ARTWORK APPROVAL

PSM/PSP-PSM-000-6819

AW006562

(731186) LOVE NATURE REFRESHING 2-IN-1 MASK & SCRUB WITH ORGANIC ALOE VERA & COCONUT WATER 75G-34822.72

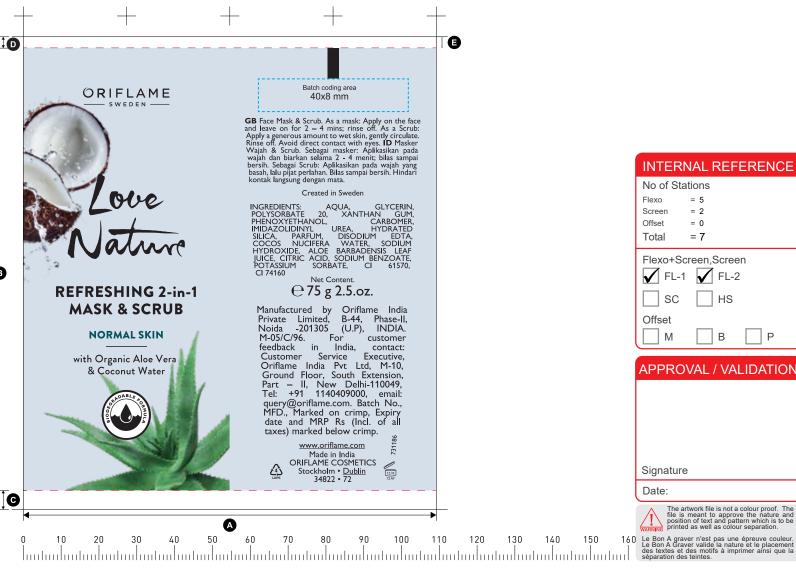
VER	DATE	COMMENT
01	27-10-2021	As per file we developed artwork
		2. The color sequence is as per the old printed artwork no AW005034
		3. Please check all thoroughly

Note:- "If no print at open end is less than 10MM there is chance of ink cracking while sealing of tube (depends upon colour of sleeve and ink), we suggesting there should be a sealing test before commercial printing"
